Blue Print ADM543111, ADM54398

Mazda CX-7 2006 > 2014, CX-9 2007 > 2016, MX-5 2005 > 2014

Brake Disc

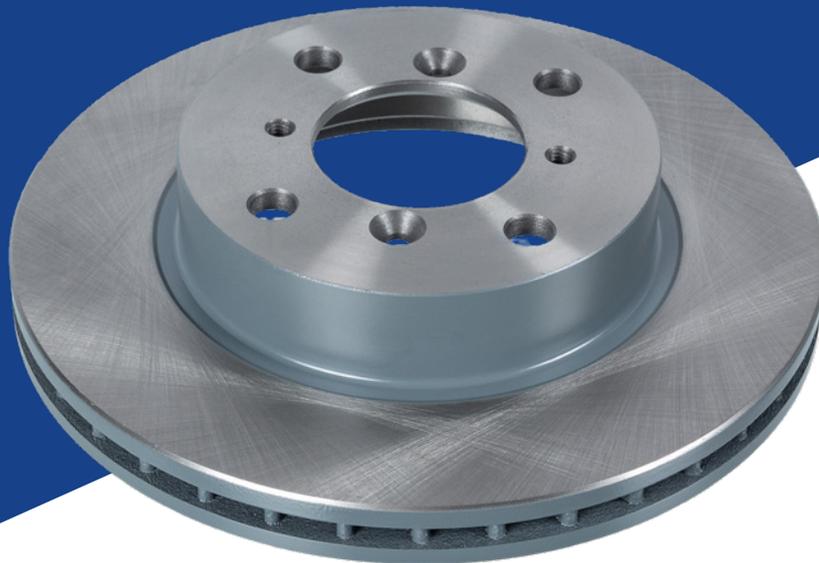
For the vehicle production period after October 2012, Mazda modified the design of the wheel hubs and brake discs - removing the retaining screw fixing points (on both the hubs and discs) as an effect.

As a result, and when replacing the front brake discs on the models listed above, it can be found that the brake disc is not secured to the wheel hub with retaining screws upon removal of the road wheel.

However, replacement Blue Print brake discs ADM54398 and ADM543111 are manufactured with two retaining screw fixing holes - allowing Blue Print brake discs to be compatible with vehicles made before and after the production date change.

ADM54398 and ADM543111 can either be used with or without the retaining screws because the road wheel secures the brake disc to the hub once the wheel nuts are tightened to the correct torque.

Using a suitable torque wrench, the wheel nut should be tightened to:

CX-7: 103 ± 15 Nm

CX-9: 128 ± 15 Nm

MX-5: 103 ± 10 Nm
